Model: Martini-C1		Date: 13-Sep-02	No.: RB064001
Subject: ROM History (Martini-C1 LCDC/Language)		Prepared by: K. Miura	
From: Technical Services sec. Service Planning Dept.			
Classification:	<input type="checkbox"/> Troubleshooting <input type="checkbox"/> Part information <input type="checkbox"/> Action required <input type="checkbox"/> Mechanical <input type="checkbox"/> Electrical <input type="checkbox"/> Service manual revision <input type="checkbox"/> Paper path <input type="checkbox"/> Transmit/receive <input checked="" type="checkbox"/> Retrofit information <input type="checkbox"/> Other (      )

Model: Martini-C1		Date: 13-Sep-02	No.: RB064002
Subject: Service Manual Revision		Prepared by: K.Miura	
From: Technical Services sec. Service Planning Dept.			
Classification:	<input type="checkbox"/> Troubleshooting <input type="checkbox"/> Part information <input type="checkbox"/> Action required <input type="checkbox"/> Mechanical <input type="checkbox"/> Electrical <input checked="" type="checkbox"/> Service manual revision <input type="checkbox"/> Paper path <input type="checkbox"/> Transmit/receive <input type="checkbox"/> Retrofit information <input type="checkbox"/> Othe

**Procedure for Adjusting the Slide Rail Fixing Screws**

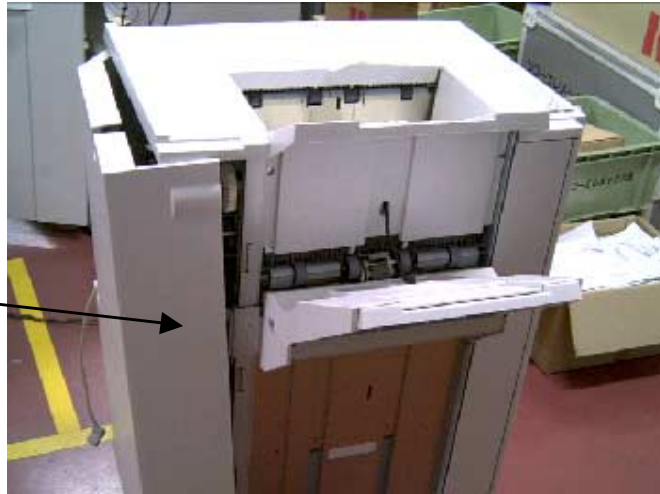
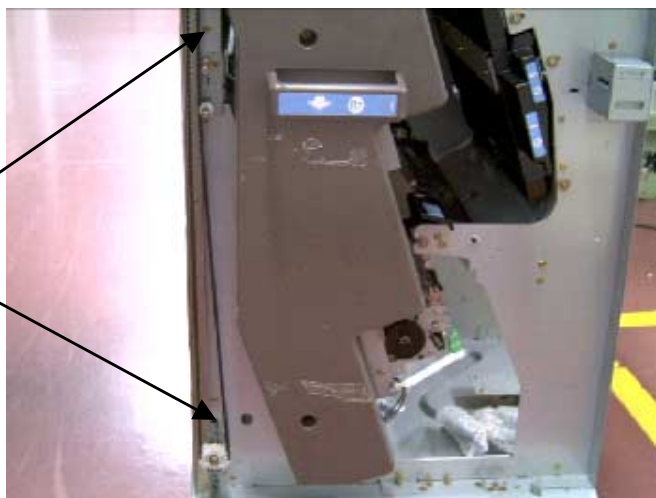
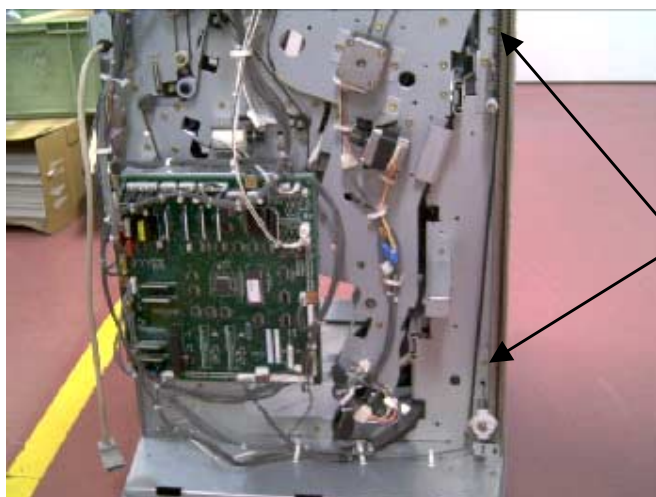
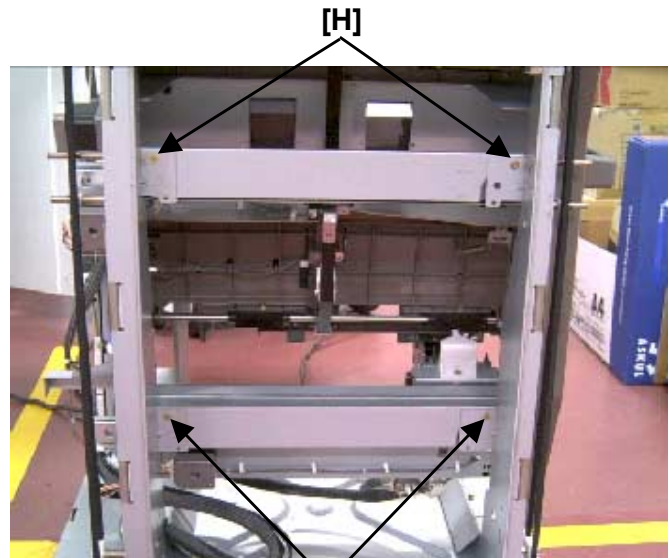
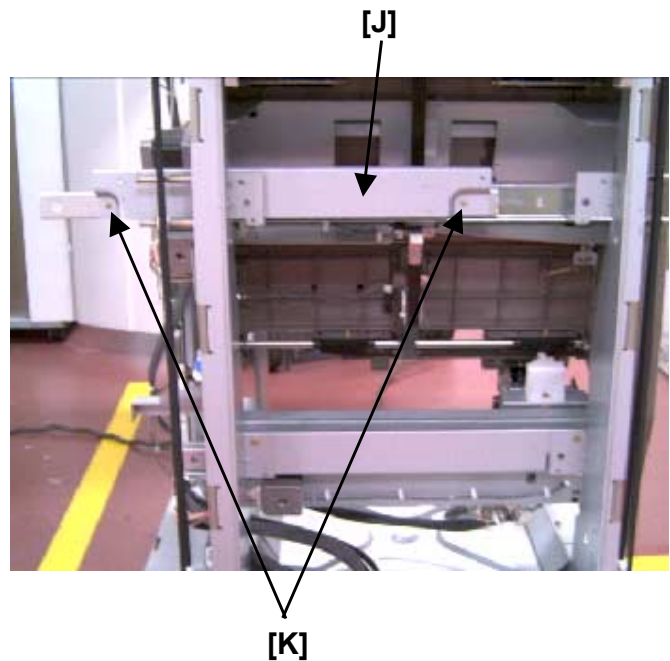
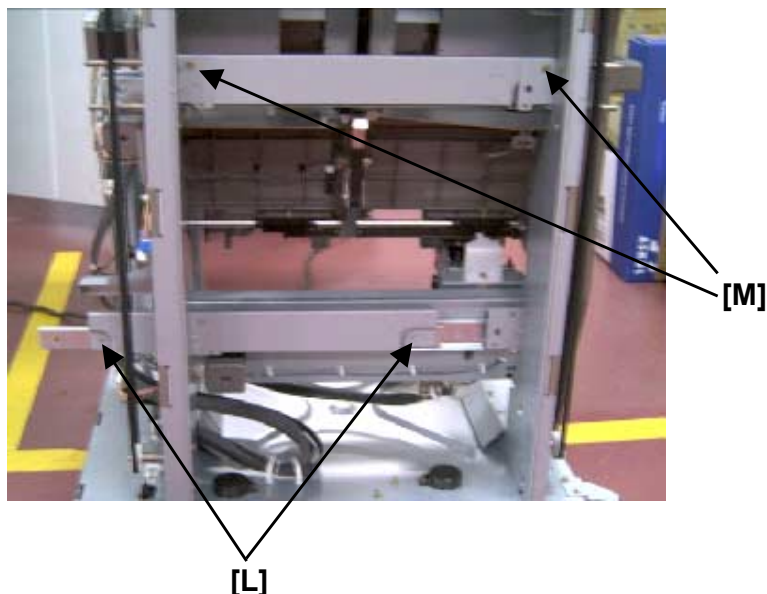
As a permanent solution, the screws have been equipped with spring-washers. As a temporary solution in the field, please perform the procedure below.

1. Remove the rear cover [A].

2. Remove the front door [B] by lifting up the upper hinge area [C], then removing the door shaft from its pivoting hole.

3. Remove the front right cover [D].

4. Remove the end fence [E] by first removing the 2 screws [F] on the front and rear plates (2 screws [G]), then pulling the lower portion of the fence outward to disconnect it from the machine.

5. Remove the fixing screws [H] for the upper slide rail unit only.

6. Slide the slide rail unit [J] toward the rear, then re-attach the fixing screws [K].

7. After making sure that the upper unit screws are tightened, remove the fixing screws [L] for the lower slide rail unit, slide the unit toward the rear, then reattach the screws [M].  
**NOTE:** Secure the screws slightly tighter than usual.

8. Secure the slide rail unit in place, then reattach all covers removed in the above steps.

## CAUSE

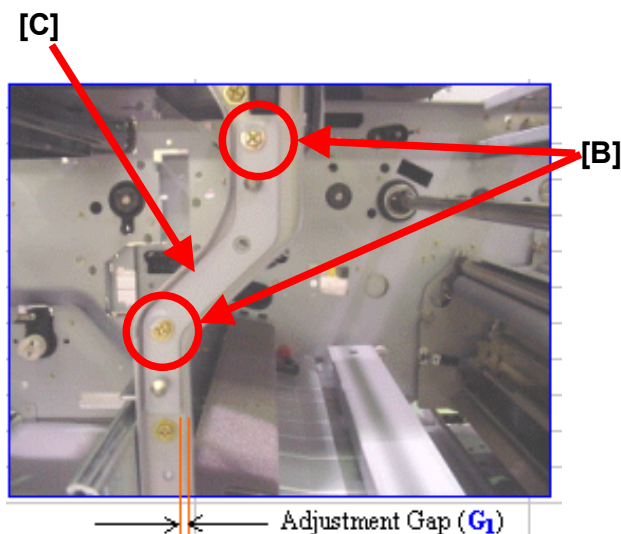
Due to a damaged special tool used on the production line, a 2.3mm gap developed between the positioning plate securing the transfer belt unit and the right edge of the machine frame (gap G<sub>1</sub> on next page, which should normally be about 1.5mm).

2. Remove the PCU Inner Cover (P/N B0651313), then remove the Transfer Unit Guide Plate [A].
3. Loosen the 2 paint-locked screws [B].
4. Insert a 1.5mm feeler gauge into the gap between the positioning plate [C] and the right edge of the machine frame (gap  $G_1$  in photo below), then tighten the two positioning plate screws.

**Release Cam Cushion Installation Procedure**

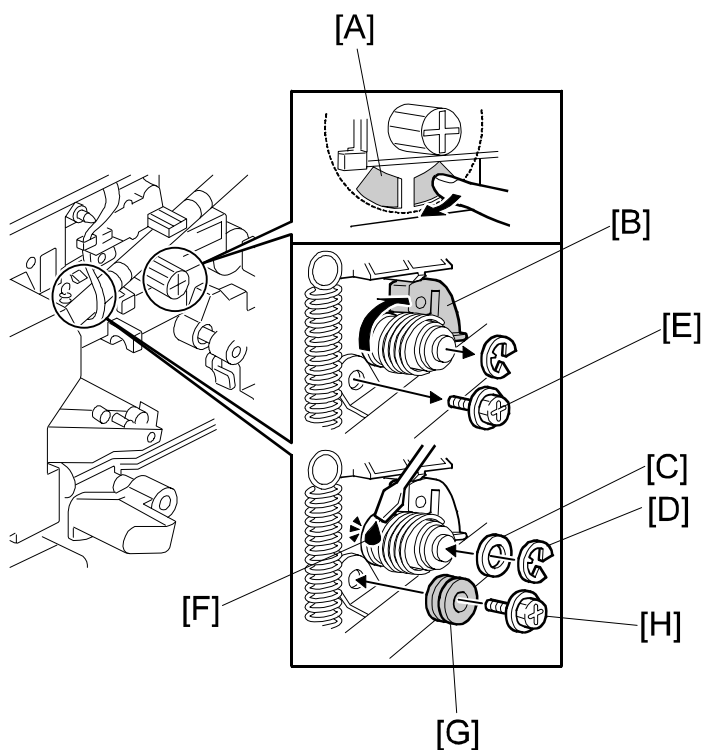
The spacers and cushion have been added from the cut-in serial numbers listed below.

1. Turn the drum flange [A] clockwise until the cam [B] reaches the position as shown.
2. Add one spacer [C] to the release cam shaft, only if there is 1 spacer already installed (1 e-ring [D]).

3. Remove the screw [E].
4. Apply grease G501 [F] to the release cam.
5. Attach the cushion [G] using the new M4x14 hexagonal screw [H].

### 3.12.1 BCU BOARD

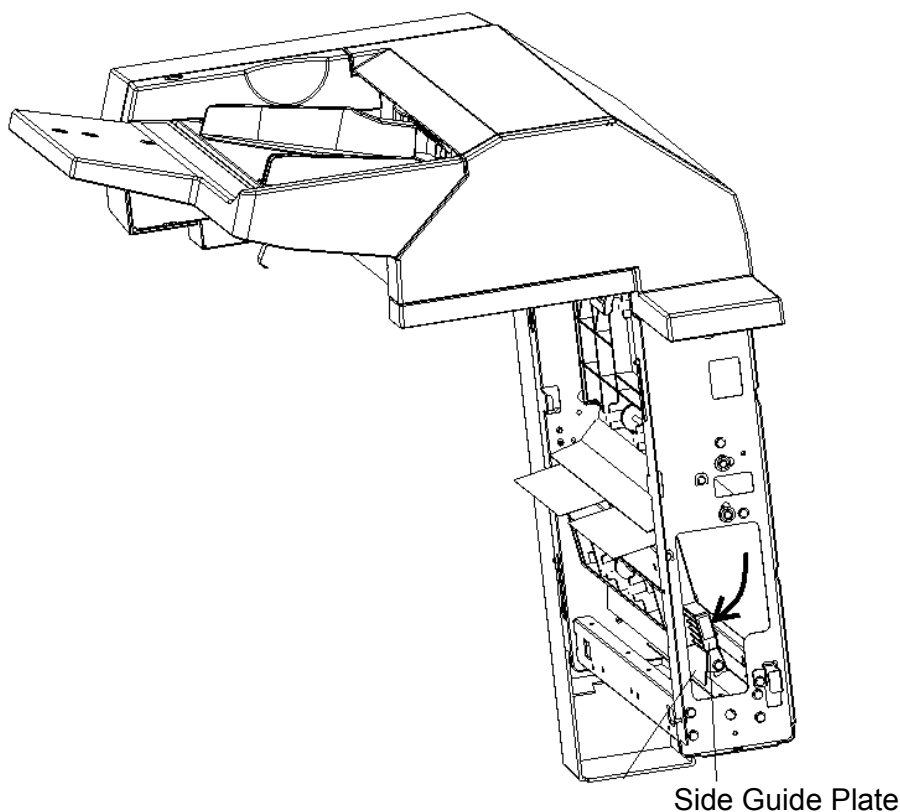
Please add the following to your Service Manuals.

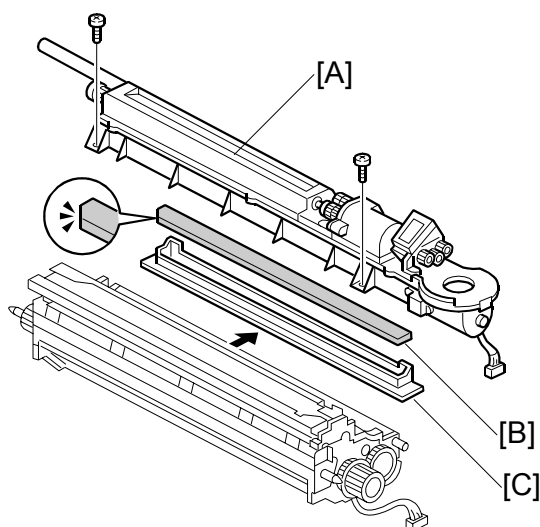
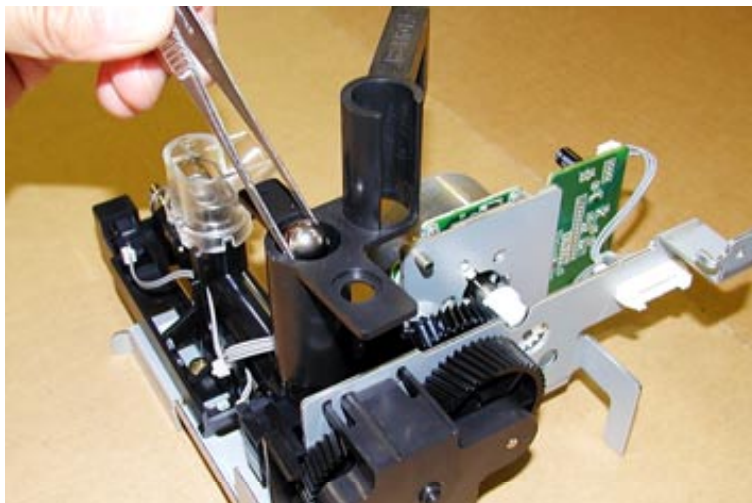
- As mentioned above, the transport screw used in the waste toner transport unit in the rear of the machine has also been changed. This is because it is possible for the new coil to interfere with the movement of the screw. The P/N change for the transport screw is: from B0653638 to B0653670. Also, the steel ball (A0963736) has been deleted for the same reason.

**Note:** The length of the coil in the Waste Toner Vertical Transport Unit has been increased as shown below (new coil on the left, old on the right). It is therefore necessary to remove the steel ball to prevent the loud noise that will occur if the coil contacts the ball.

- Replace the Gear (B0653138 and/or B0653139), and
- Replace the Toner Supply Unit (B0653111) and Waste Toner Vertical Transport Unit (B0653554), and
- Remove the steel ball (A0963736).

1. Disconnect the connector.
2. Remove the snap ring.
3. Remove the drive rod.
4. Replace the Waste Toner Vertical Transport Unit (install B0653554, 1 screw, 1 snap-fit).

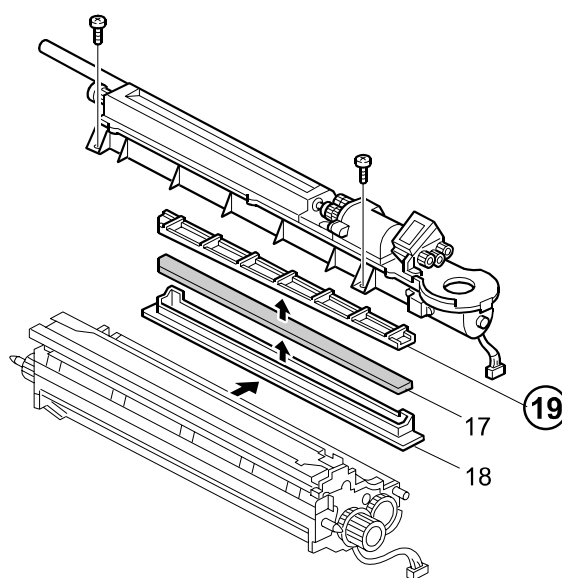
A Filter Case (B0653108, index #19 below) has been added on top of the Development Filter to ensure the filter stays properly closed. This information has been announced in MB064008, containing the cut-in serial numbers.

1. Whenever replacing the Development Filter, always make sure that the filter lies at or below the level of the surrounding casing.
2. Add the new Filter Case on top of the Development Filter, referring to the following procedure:

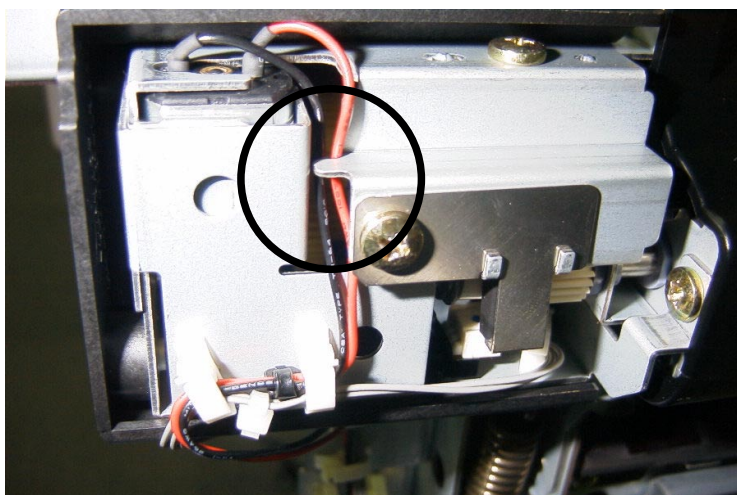
The harness position has been changed as shown below.

**SOLUTION**

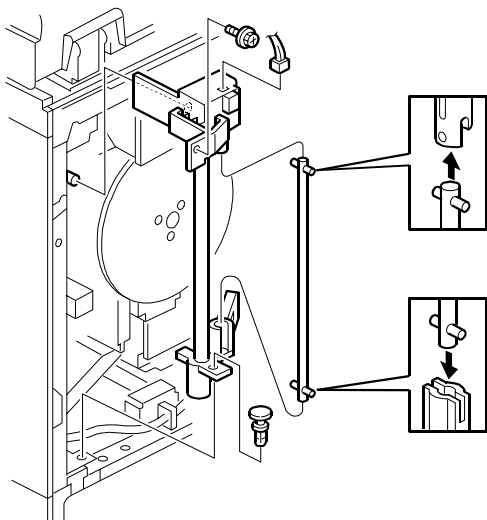
Attach the Feed Lever (P/N #B0656445) to the Drive Reverse Shaft.

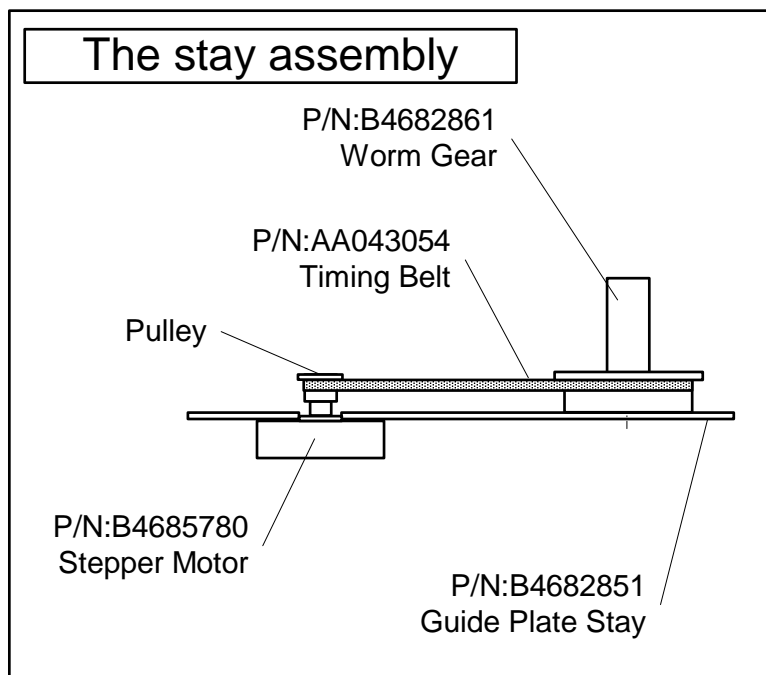
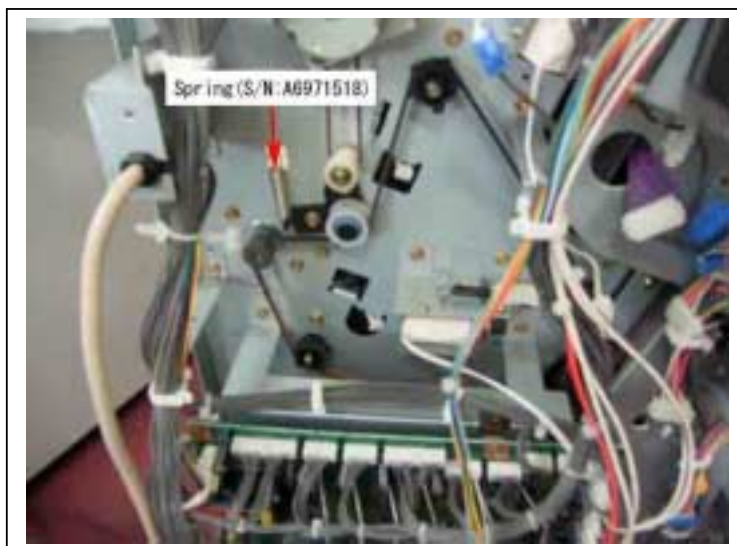
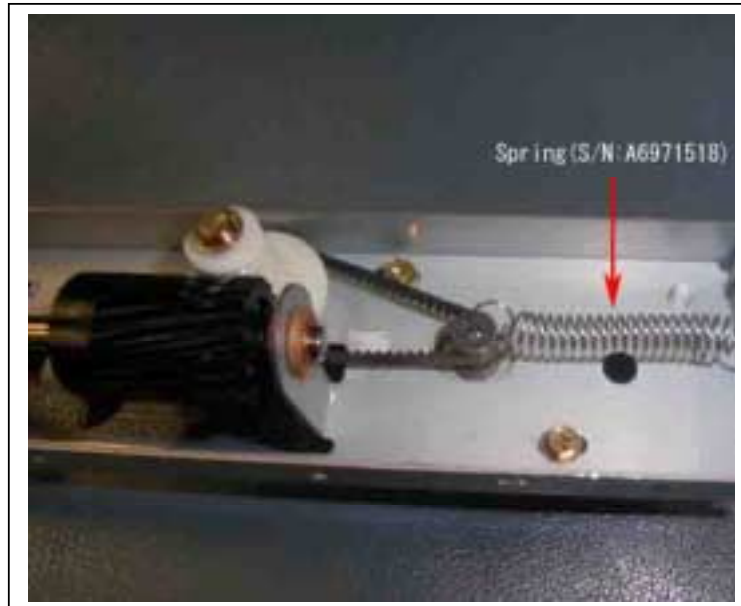
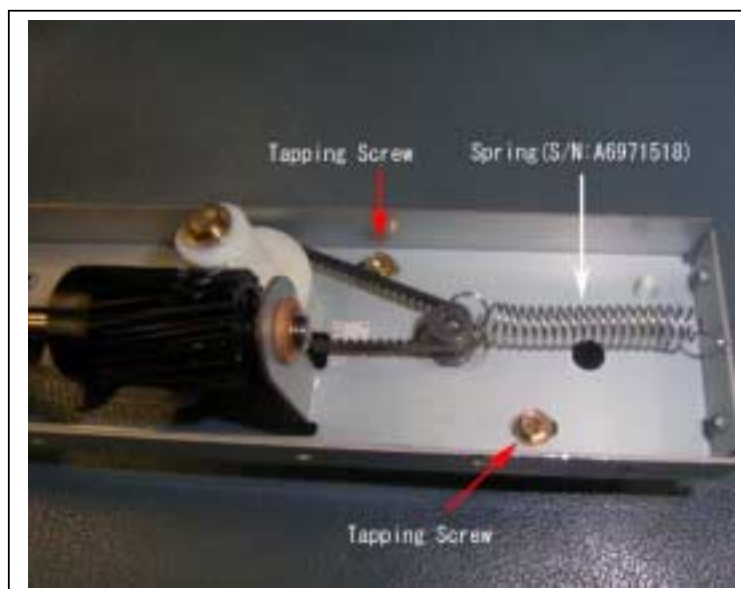
1. Remove all of the following shift-transfer section components (P/C: pg. 13).

2. Remove the spring (P/N: A6971518) located in drive section 2 (P/C: pg. 41, index 12).

3. Attach the spring removed above to the area shown below (one end to the motor pulley, the other end to the edge of the stay). This spring will be used to apply the optimum tension in the belt ( $6 \pm 3.5\text{N}/3\text{mm}$ ).

4. Loosen the two tapping screws shown below (P/N: 04513006B) and allow the belt to settle to its new position (pulled by the spring).
